Research Report 1434

**Human Factors Assessment:
Light Armored Vehicle,
Maintenance/Recovery Vehicle (LAVM/RV)**

December 1986

Figure 3. The crane blocks the opening and closing of the rigger's hatch.

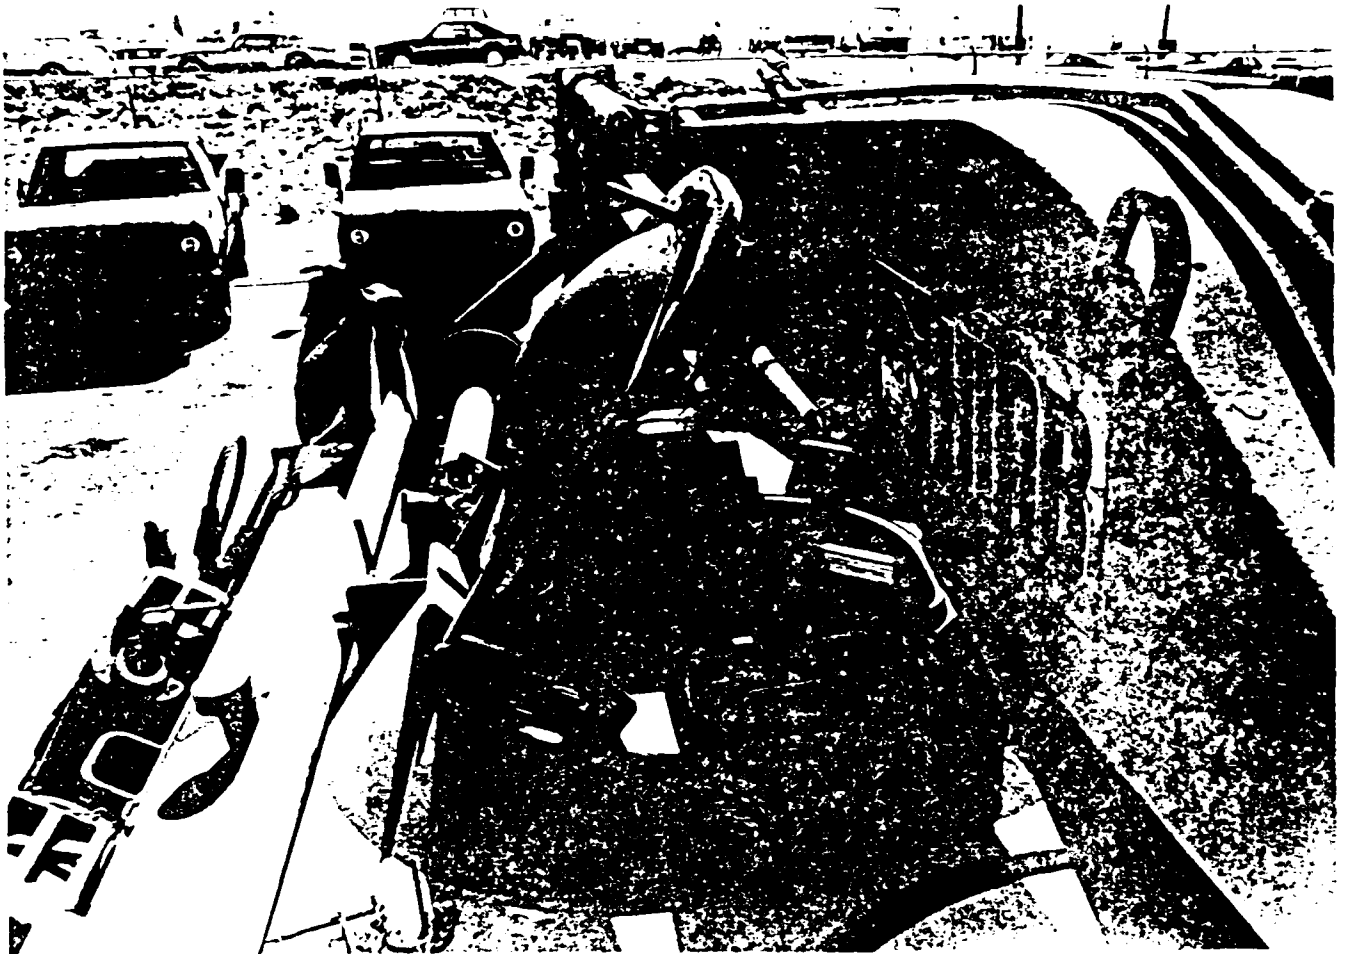
Hatches and doors. Sixty percent of the crew reported safety hazards involving obstructed hatches and rear doors. Figure 3 shows the crane blocking the rigger's hatch while Figure 4 shows the towing pintle blocking the rear doors. Both hazards prevented the rear crew positions from being occupied during testing when the vehicles operated "buttoned-up." The safety hazard also prevented the human factors specialist from obtaining instrumented measures of noise, ventilation and lighting under these conditions. Unless corrected, the crews cannot rapidly enter or exit the vehicle. Moreover, the rigger cannot button-up without operating the crane. The hazards become especially dangerous if the vehicle is being attacked or if evacuation is necessary.

Add pivot hinge for rigger's hatch.

Figure 5. The M60 gun mount (above the open hatch) blocks the opening or closing of the driver's hatch.

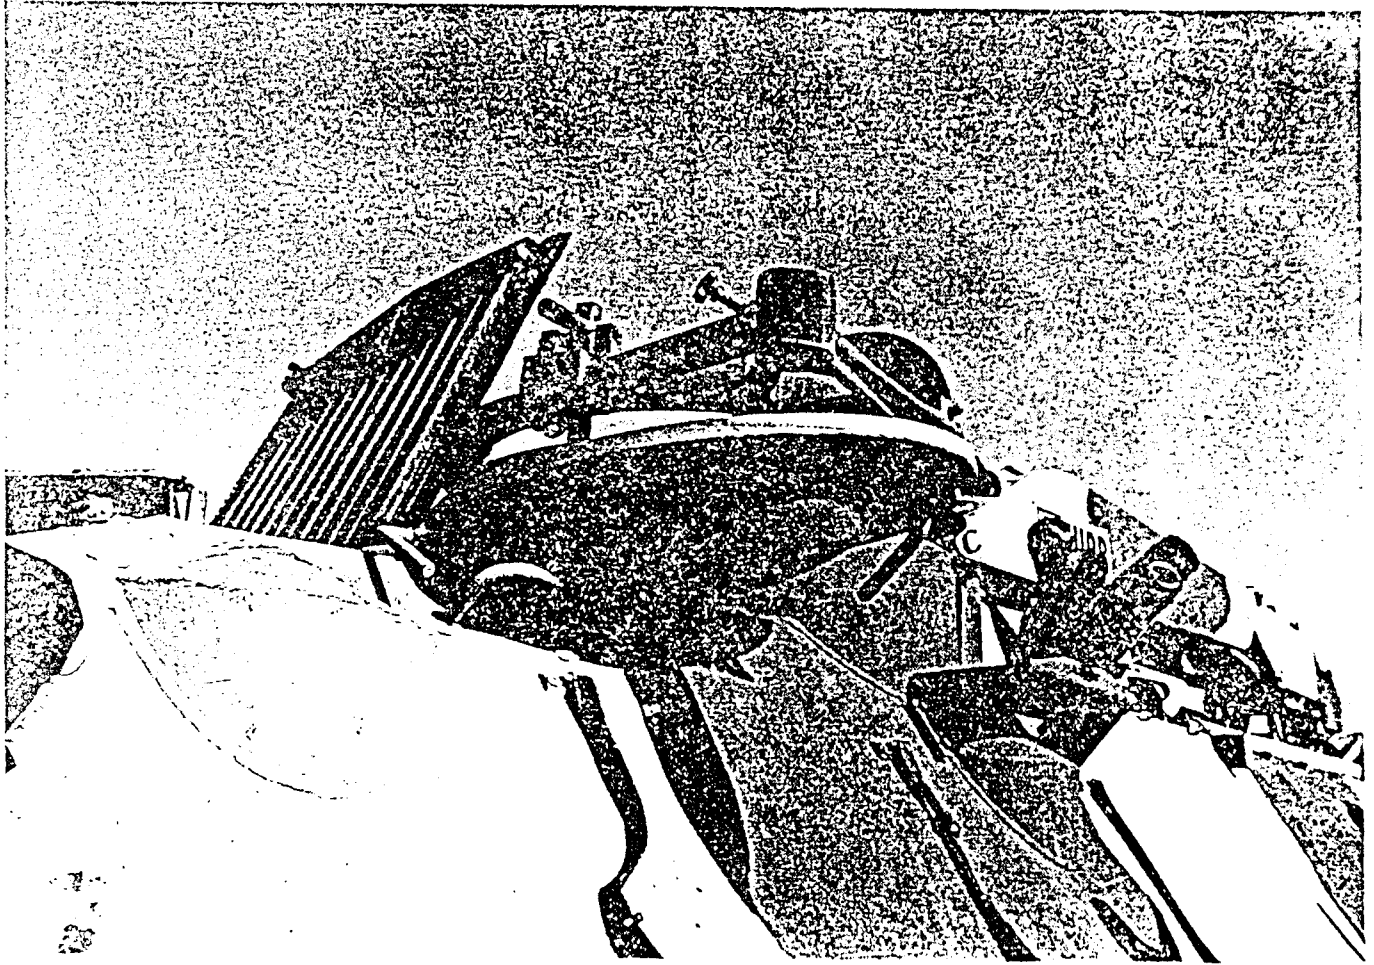
Additionally, both drivers reported that the M60 machinegun and mount, when traversed over the driver's hatch, blocks the hatch (see Figure 5). The gun and mount not only interfere with entering or exiting the driver's station but they also may endanger the driver's life when the gun is firing.

Raise or change position of machinegun mount.

Figure 7. Power pack grills are without a nonslip surface.

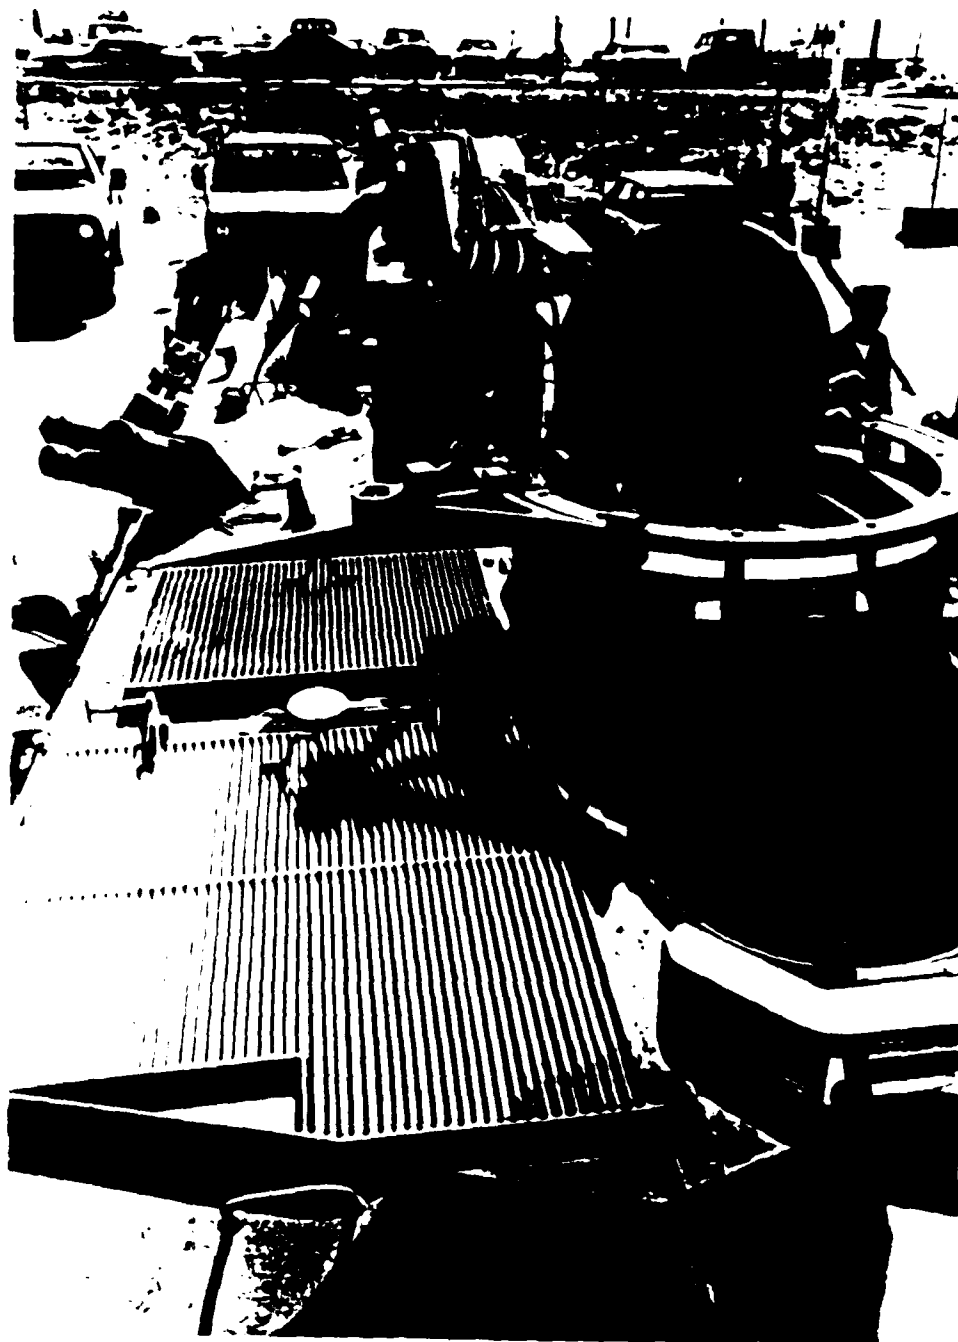
28.	Top walking surfaces	1	No friction producing surface on power pack grills.	Slip and fall injury likely when wet or oily.
29.	Steps and handholds	2	No friction producing or gripping teeth on footholds.	Slip and fall injury likely when wet, muddy, icy or oily.

Add nonslip surfaces to grill and steps/handholds.

Figure 8. The gear shift (left) and transfer case lock (right) are too similar and may be accidentally activated.

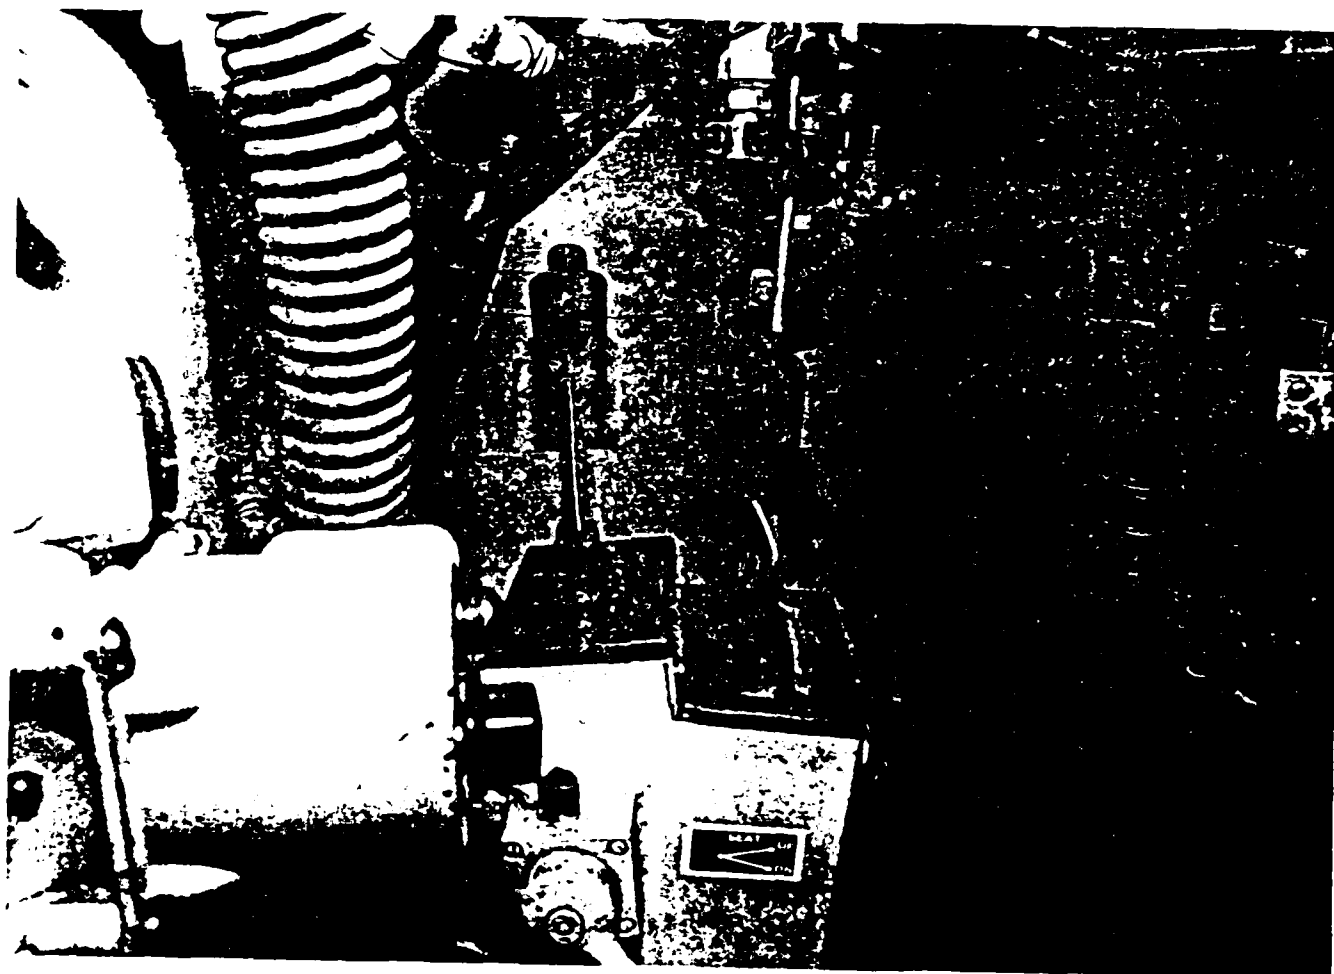
Driving controls. Both drivers interviewed reported several control/display location problems. Figure 8 shows the gear shift and transfer case lock levers. These control levels are identical and located to the driver's left side. The gear shift lever is on the left and is the farthest lever from the driver. It is also the most frequently used lever. The lever handles are approximately three inches apart. Human factors deficiencies include:

1. The drivers have difficulty determining which lever is in their hand by touch alone.
2. The drivers have difficulty determining which lever is in their hand by position alone. The levers are close together and one lever is slightly higher than the other. The driver's seat height has a wide range of adjustability in height (10.5 in (27 cm)). Thus, the lever heights relative to the driver's seated height change and are not reliable cues.
3. The less frequently used transfer case lock lever may be bumped by the driver's arm or hand when he tries to use the gear shift lever.
4. Accidental activation of the transfer case lever is likely to result in damage to the vehicle's drive train.

Design changes might include separating and relocating the control levers. In addition, position the gear shift lever closer to the driver than the transfer case lever. Change the knob configuration of the transfer case lever. A "T" handle shape might be a helpful shape code that distinguishes the transfer case lever and initializes its function.

Figure 10. The on-board crane control lever symbols are difficult to view.

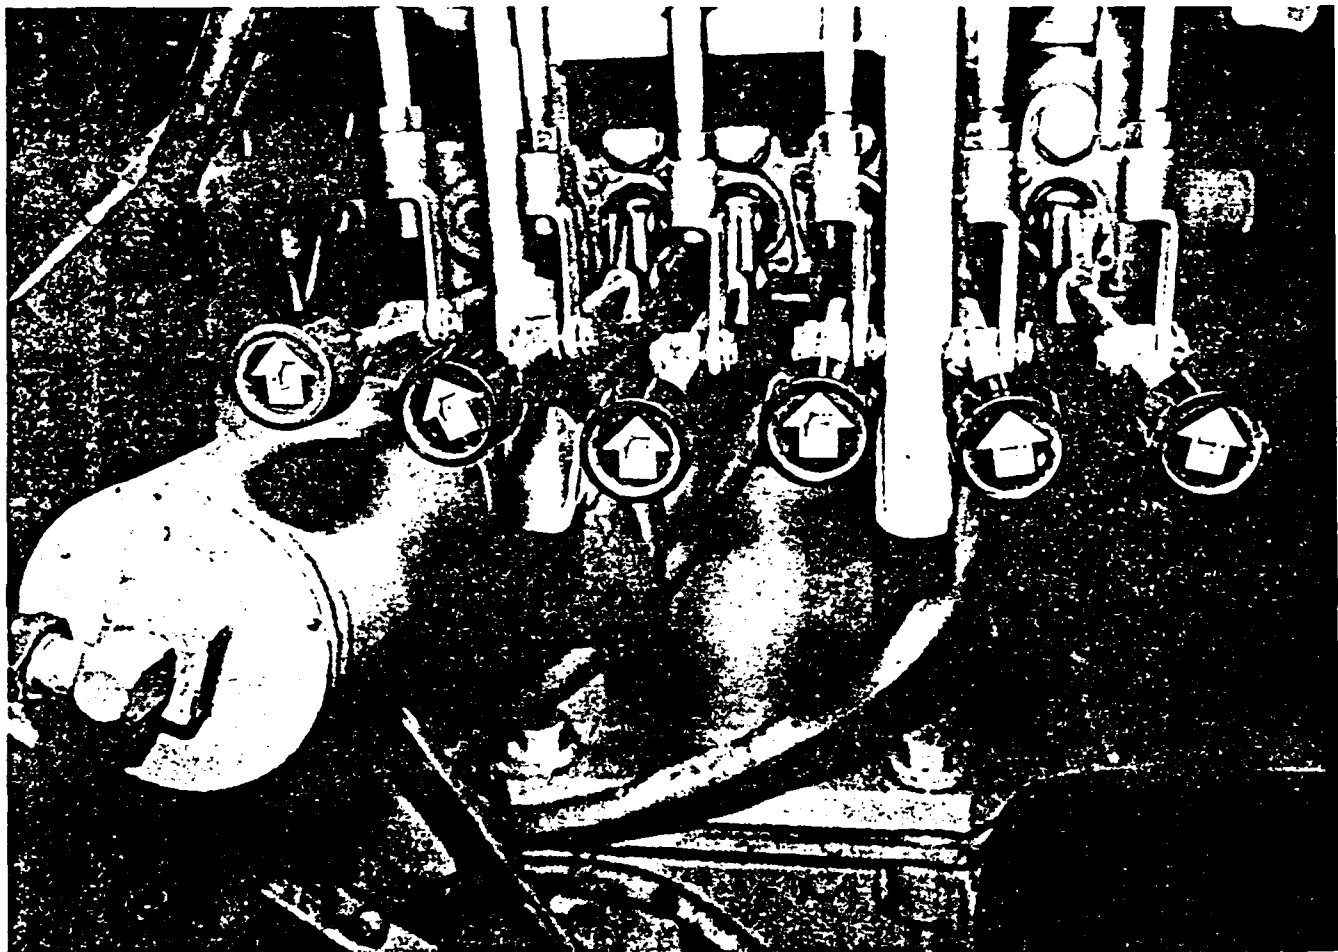
On-board crane controls. The crews rated the use of the on-board, base-mounted crane controls as borderline (mean rating, 3.3). Thirty percent of the crews felt that it was hazardous to use the on-board control because the crane cannot be viewed from the control station. Figure 10 shows the on-board control station and the symbols on the levers. The on-board controls will be used when the remote controls are inoperable, foul weather occurs, threat of combat occurs, or if a single, quick adjustment to the crane's stored position is necessary. The controls are located behind the commander's station and approximately seven inches above the vehicle floor. The controls have several human factors deficiencies, including:

1. The operator cannot view the crane responses to the control lever movements. The operator can see very little crane movement through the periscopes. Moreover, the operator's head height when handling the control levers is approximately 20 in (51 cm) below the open hatch level. Finally, the control levers are 119 in (302 cm) from the rear doors, making it impossible to view the crane's movement.
2. The control symbols are too small to be easily viewed. The symbols within the larger arrows are less than one-quarter inch in height. The symbols cannot be seen in low light or blue light conditions.

3. Control lever activation directions are the opposite of the machine response directions. Activating the inner and outer arm levers by moving them up causes the inner and outer crane arms to move down (the control levers are the second and third levers from the left in Figure 10).
4. The control knobs become unscrewed and often symbols point in incorrect directions.

Human factors deficiencies such as those listed above are likely to increase task completion time, errors, and may result in equipment damage or injury. All crane control levers should move in the same general direction as the crane functions they control. Design changes might include reversing (if possible) the position of the input and output hydraulic lines on the manifold for the inner and outer arm levers. Place larger control symbols directly in line with the control levers on the valve manifold housing (not shown in Figure 10). It may also be possible to turn the valve manifold over, appropriately switching the input/output lines, so that the control levers are closer to the commander's hatch and can be activated in the appropriate directions. This would also place the control symbols closer to the overhead light.

Figure 11. The equipment carried inside the vehicle. Additional combat gear is not shown.

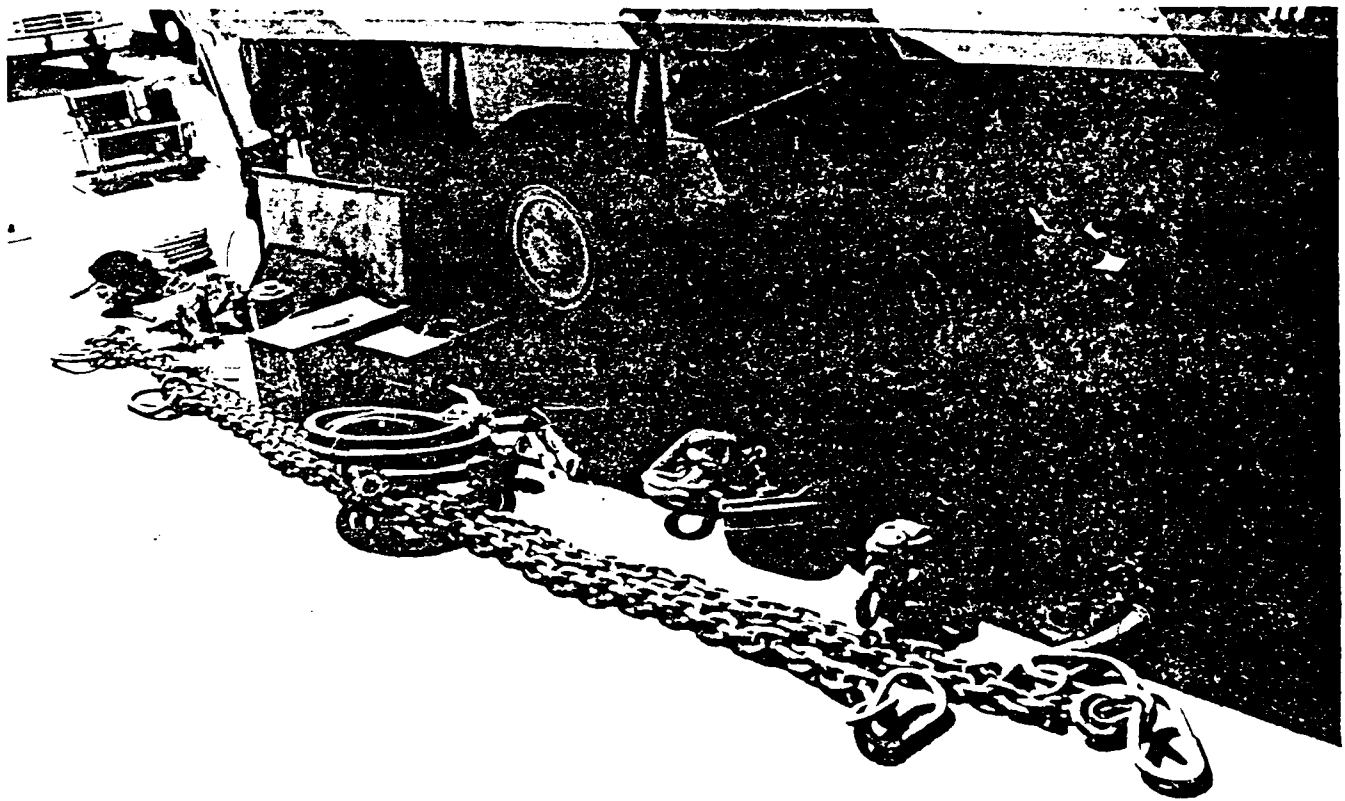
Tool and accessory storage. Crews rated the size and location of storage and the protection of equipment in storage as borderline (average mean rating, 3.1, see questionnaire items 43 to 46). Figure 11 shows the equipment carried in internal vehicle storage locations. Figure 11, however, does not show any combat gear which is also stored inside the vehicle. Figure 12 shows the equipment as it is usually stored in the vehicle. Notice that stored equipment is blocking the passageways. Figure 13 shows two of the three secure storage spaces allocated for all the equipment shown in Figure 11. Secure storage consists of two equipment trays (measuring 26 x 7 x 7 in (66 x 18 x 18 cm)) and one tool box (measuring 19.50 x 13.25 x 10 in (50 x 34 x 25 cm)). The lack of secure storage locations results in the stacking of equipment in any available space. The crew also reported that they stored equipment in their seated legroom and carried equipment in their laps when the vehicle was combat loaded. The lack of secure storage results in several problems, including:

Add secure storage space.
